10/694,723

HOUSTON, ELIZABETH

Office Action Summary

FIG. 12a

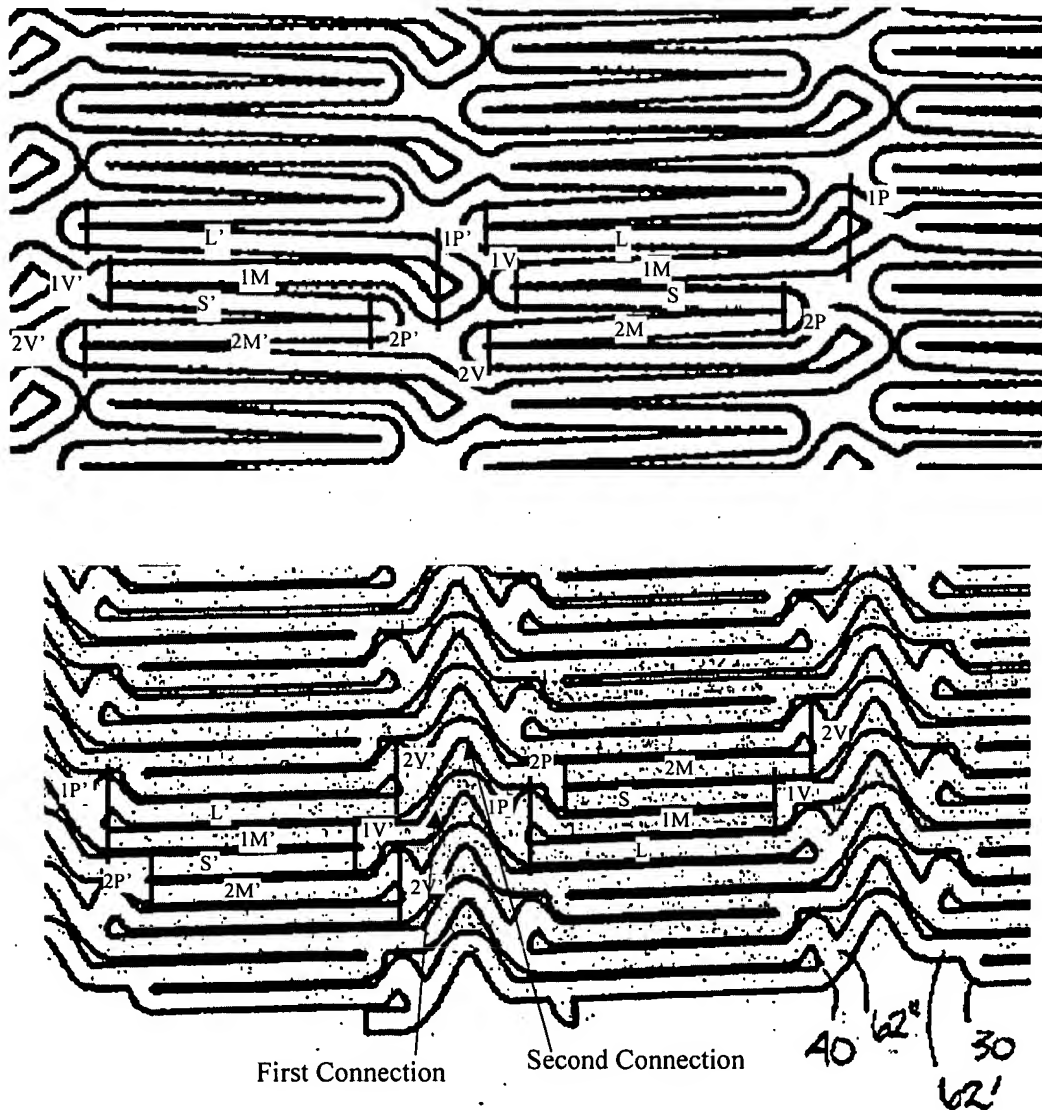
6. Lowe discloses a stent in Figures 23 and 24. The figure is copied and labeled below to depict the long segment (L), first peak (1P) being defined by a single turn radius, connecting with a midsize segment (M), connecting with a first valley turn (1V), connecting with a short segment (S), connecting with a second peak turn (2P), connecting with a second midsize segment (M), and connecting with a second valley turn (2V), connecting with a long segment of the adjacent series. It should be clear that the first peak turn of one element is connected to the first valley turn of an adjacent element. Each element has a first connection point connecting a first peak of the first element to a first valley of an adjacent second element and a second connection point connecting a second peak of the first element to a second valley of the second element. The connection points form a double helix pattern. The elements are formed connected, welded or from toroidal rings (Para [0095]). The stent is balloon expandable (Para [31]). Regarding claim 19, the connecting member (64, Fig. 12) spans between one of the

long segment of the first element and one of the long segments of the second element in both a longitudinal and radial direction. Note that the claim does not require that the connecting member extend directly from the long segment but rather in the broadest interpretation, merely requires that the spans in a radial direction somewhere between the two segments.
